**ADDENDUM NO. 2**  
**February 10, 2025**

**DLH North Business Development Area Hangar**  
**City Project No. 25-4401**  
**Duluth International Airprt**  
**Duluth, Minnesota**

**SEH No. DULAI 180746**

BUILDING SECTIONS

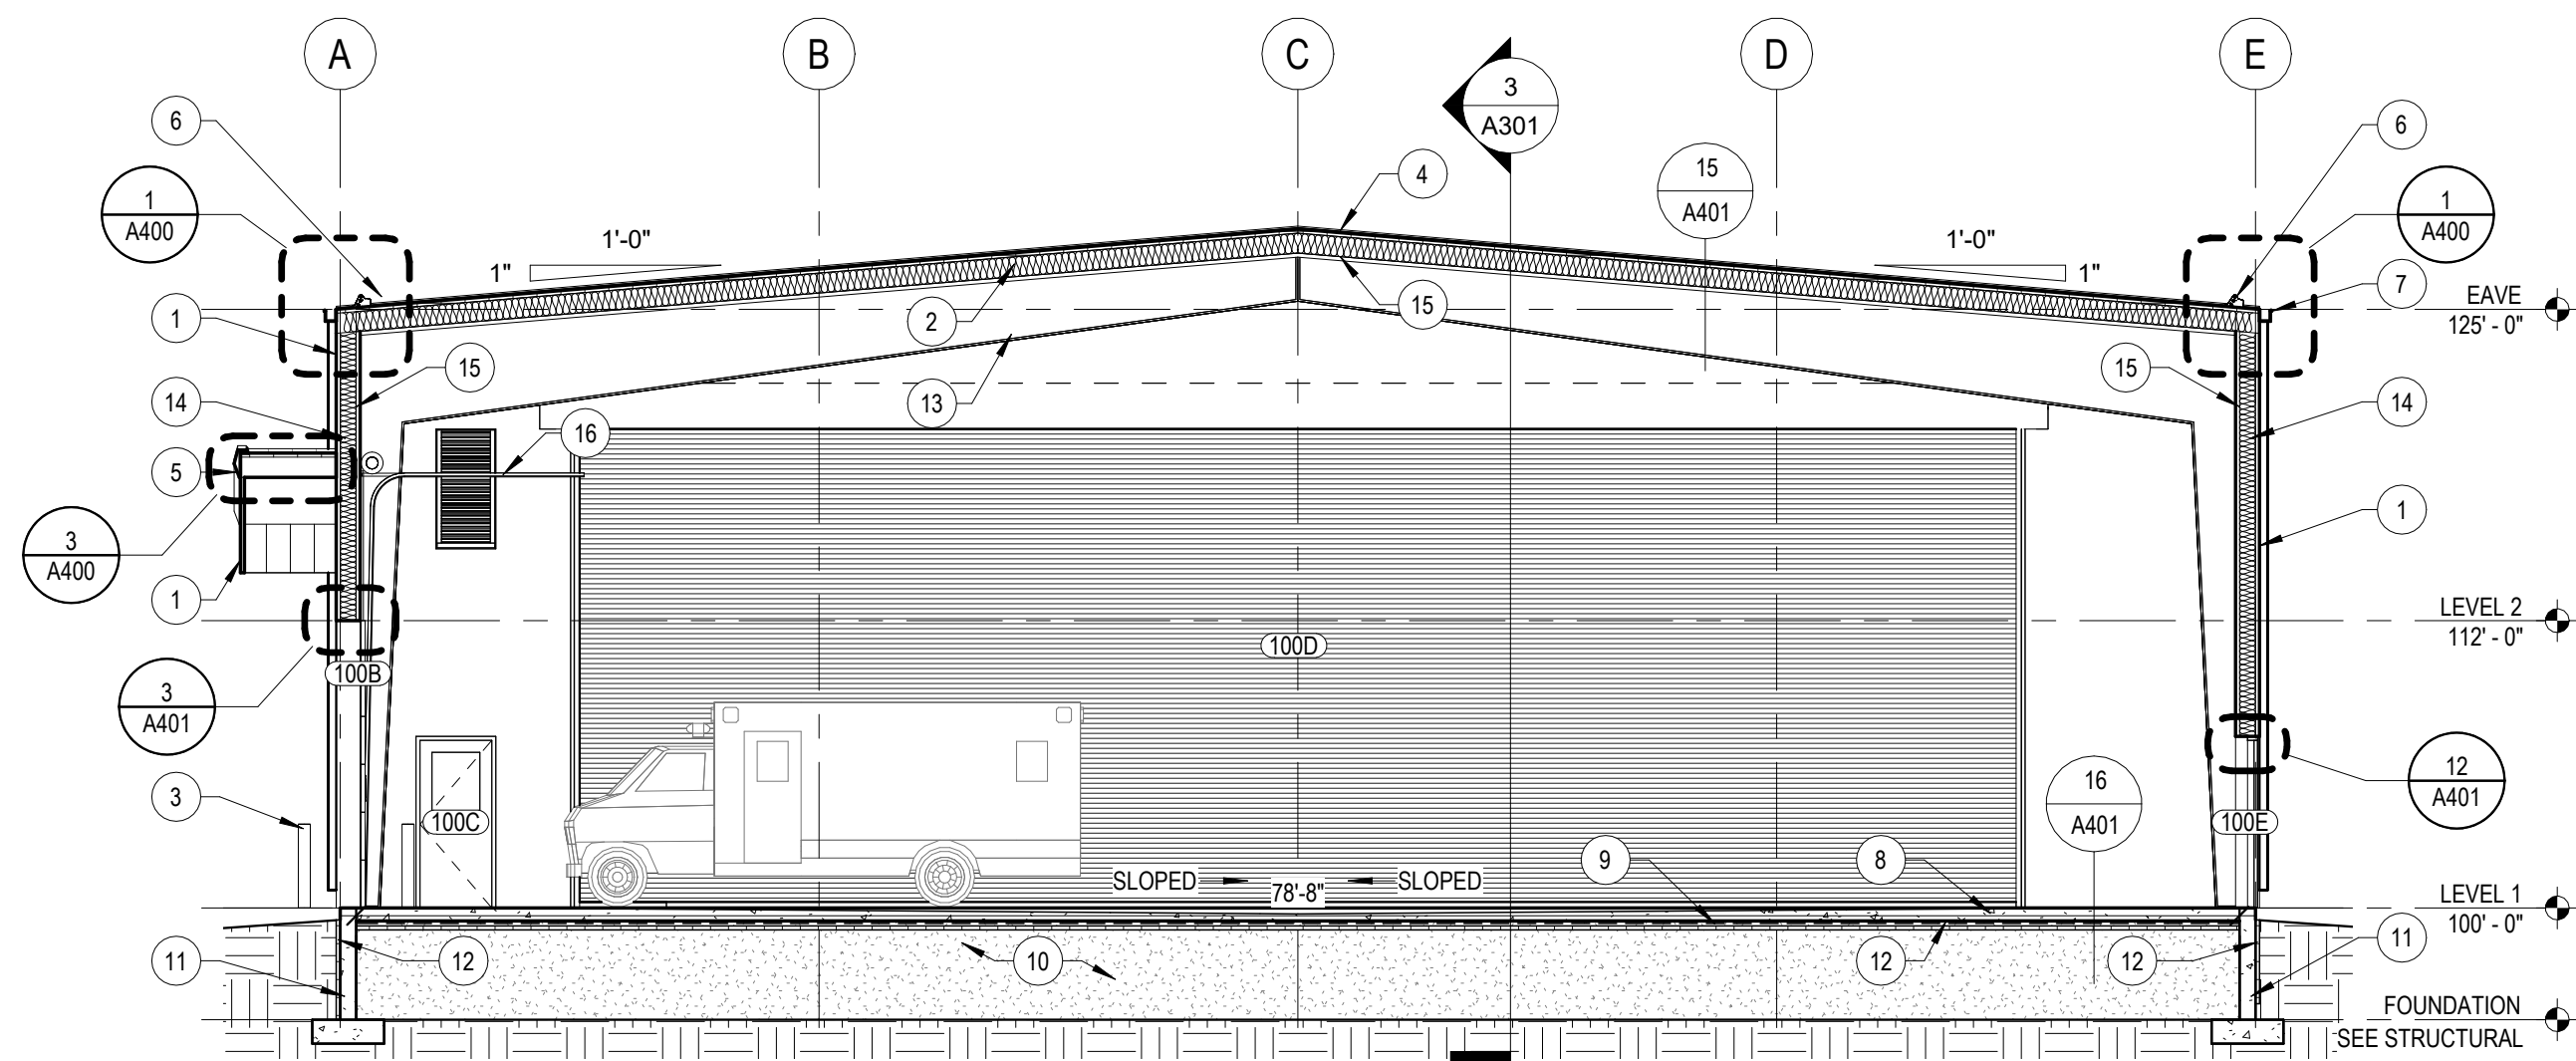
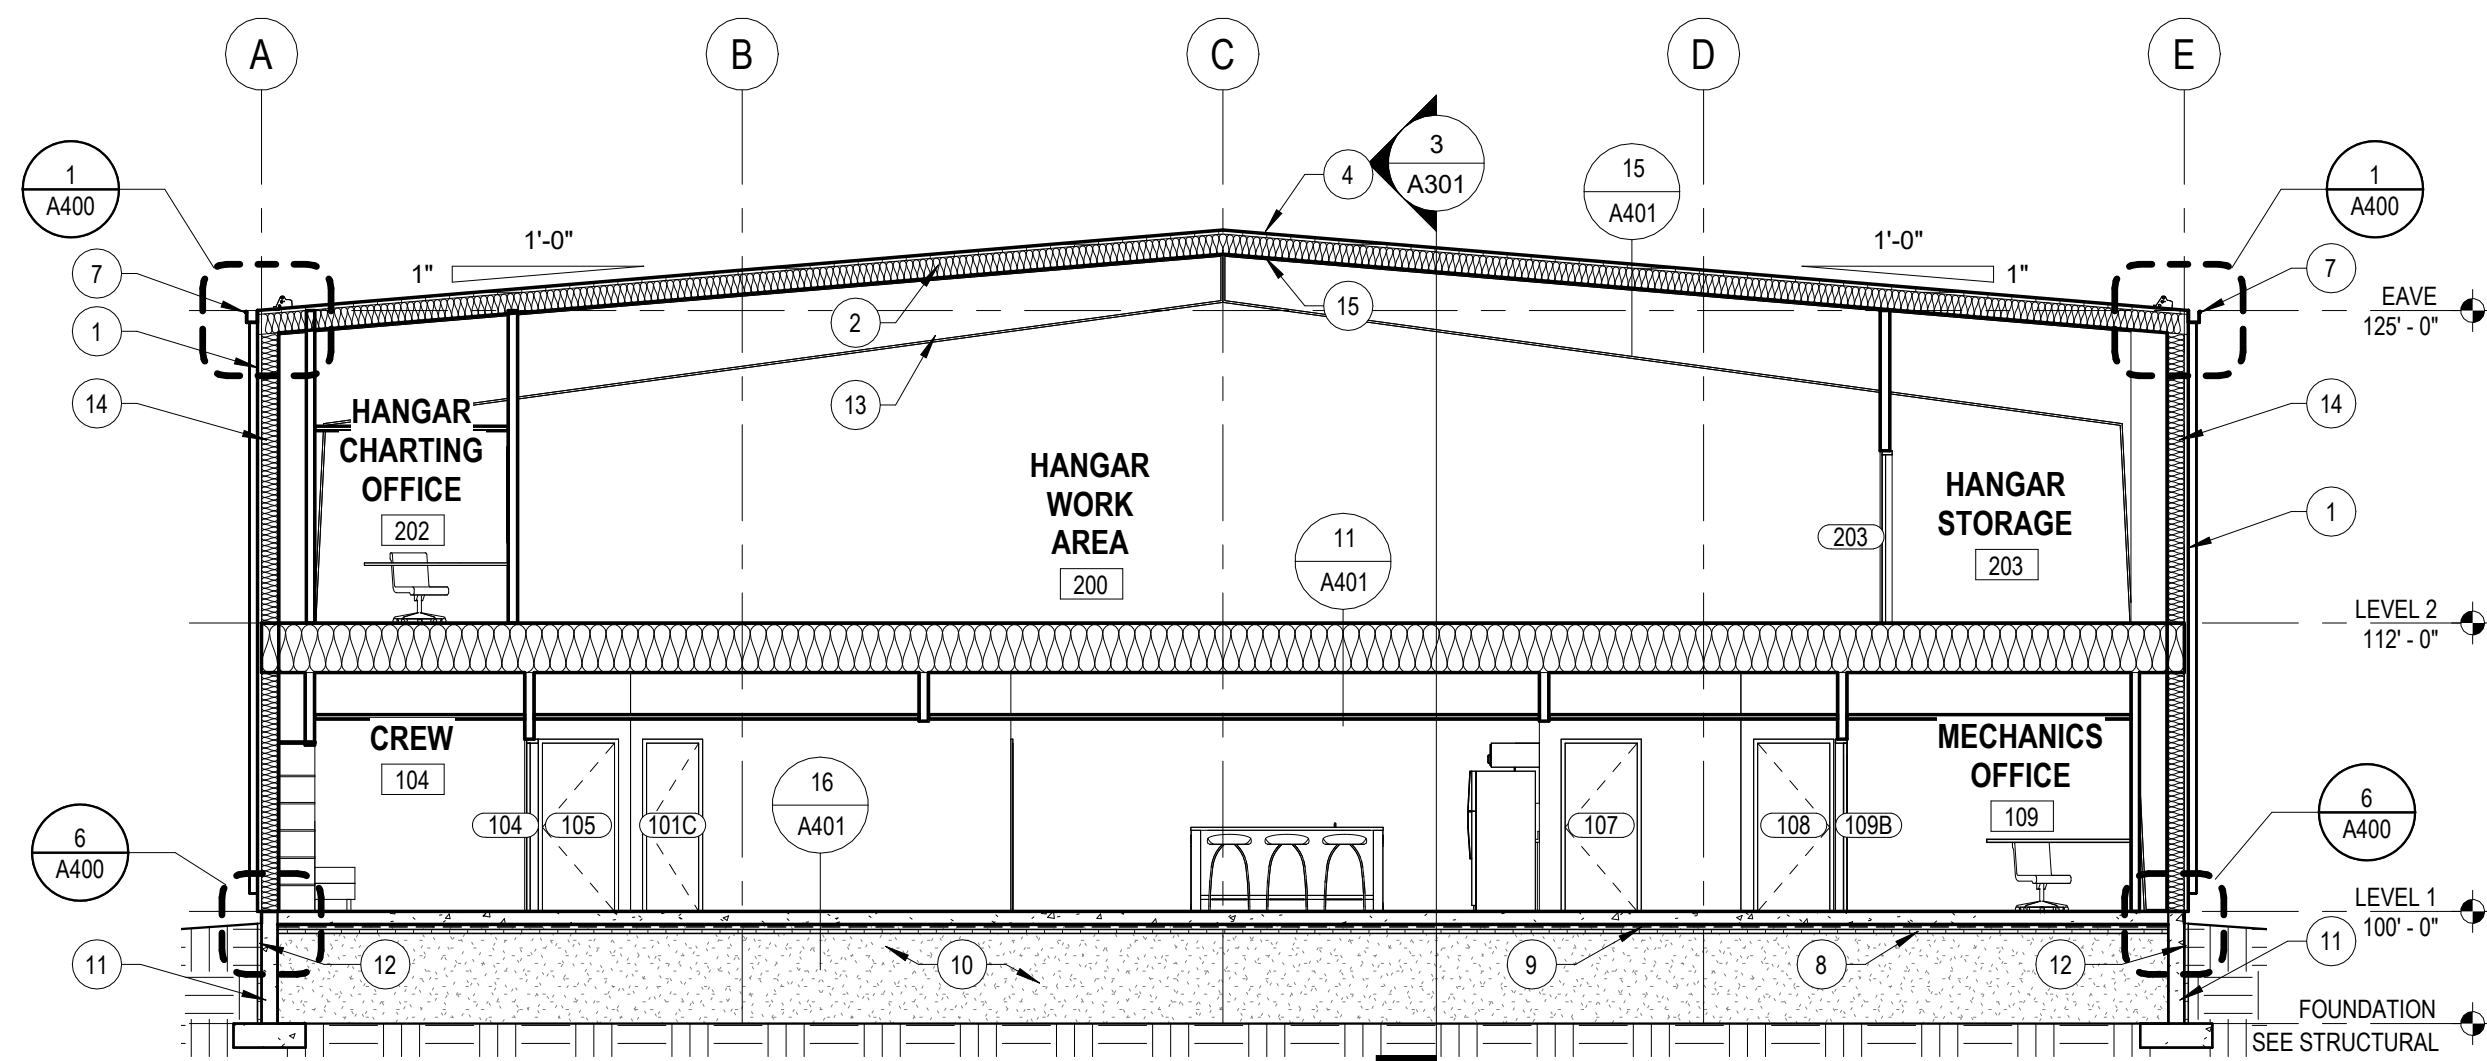
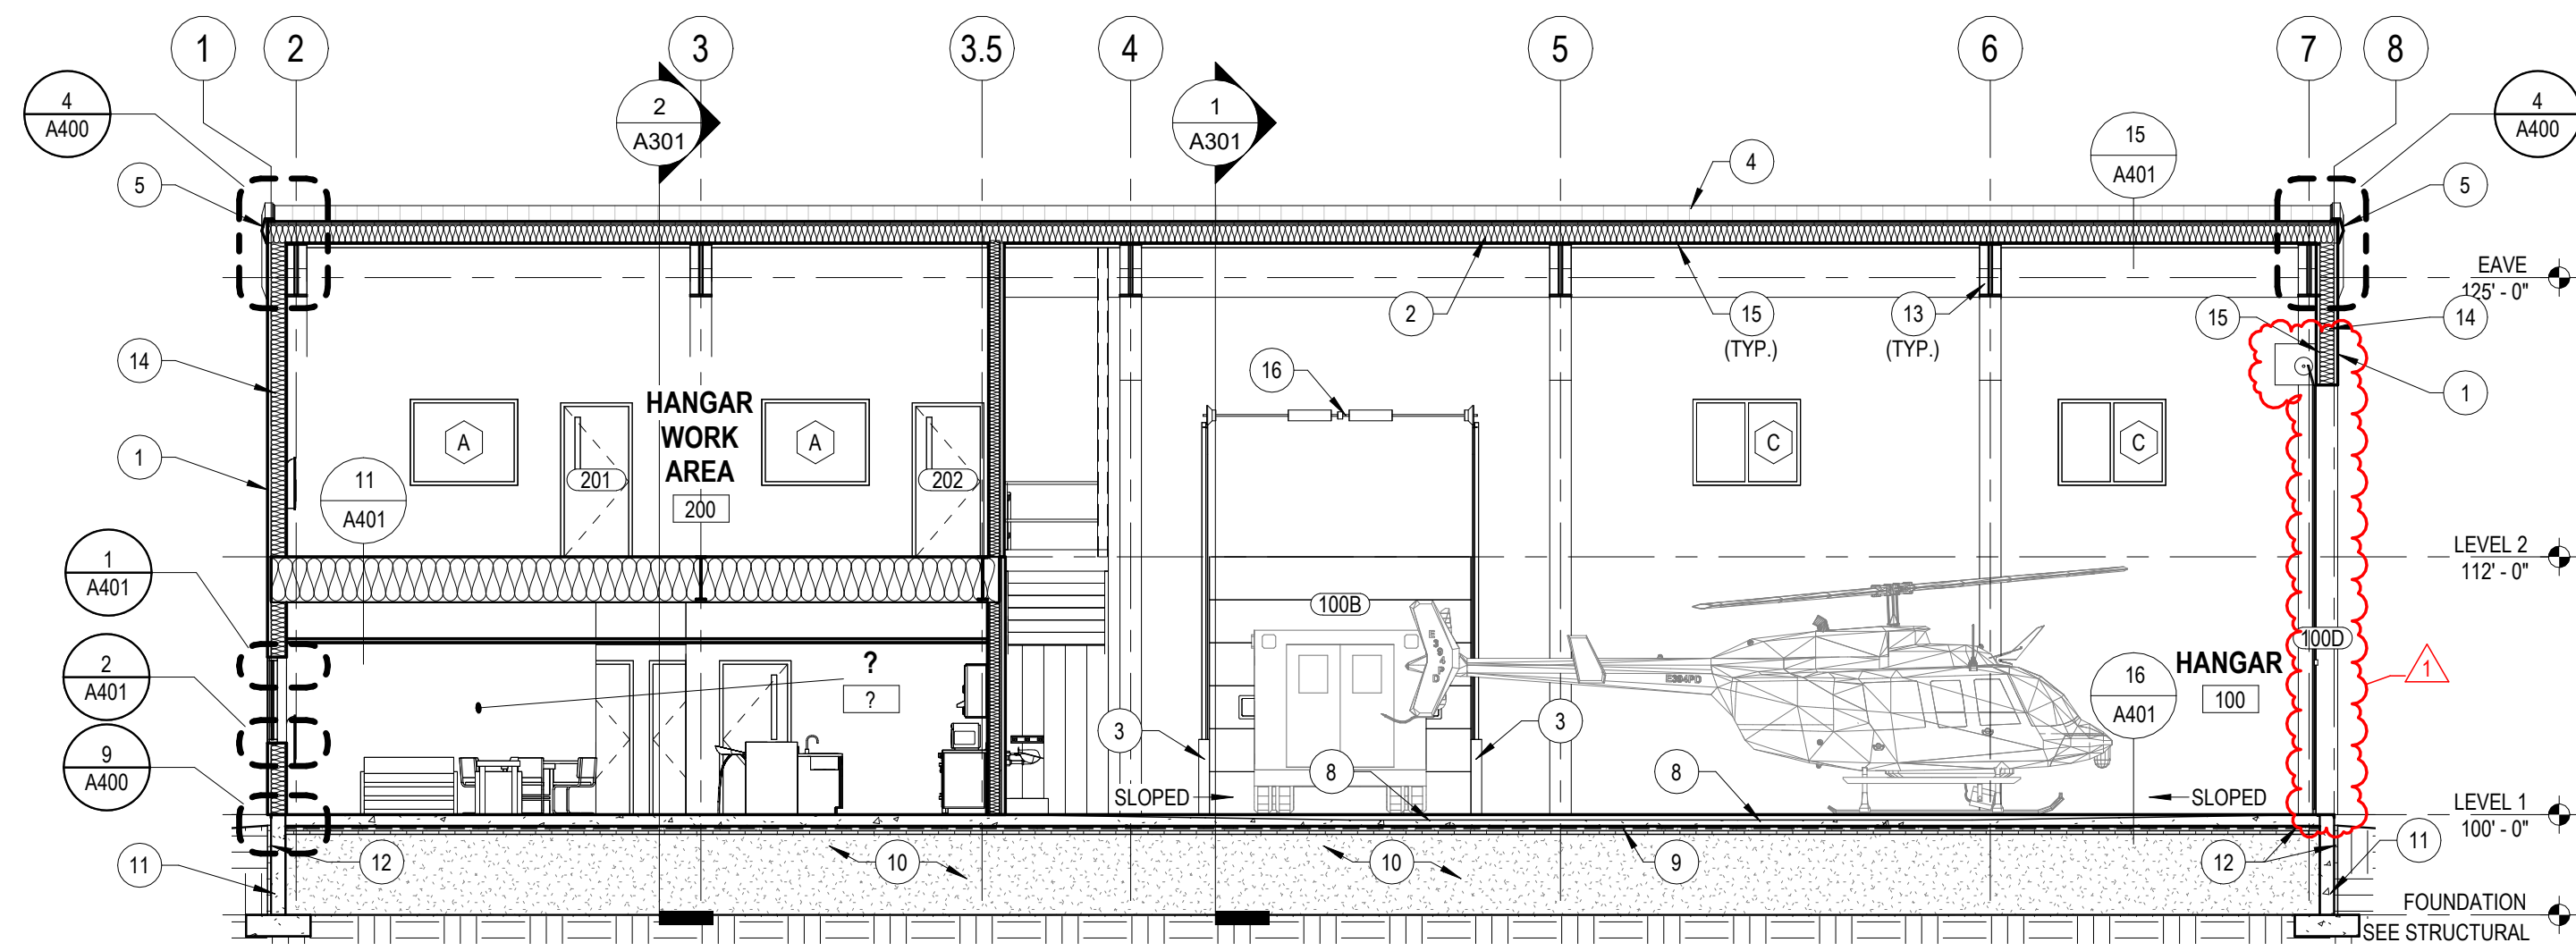
6. Q: I need clarification on the bi-fold door size. Is it 60x16 clear open when the door is open? According to the drawing the architect is showing the top of the door at 16' which would make the bi-fold 13' 6" when open. Please clarify.

*A: See updated attached Architectural sheets. This bi-fold door clearance will need to be 16'.*
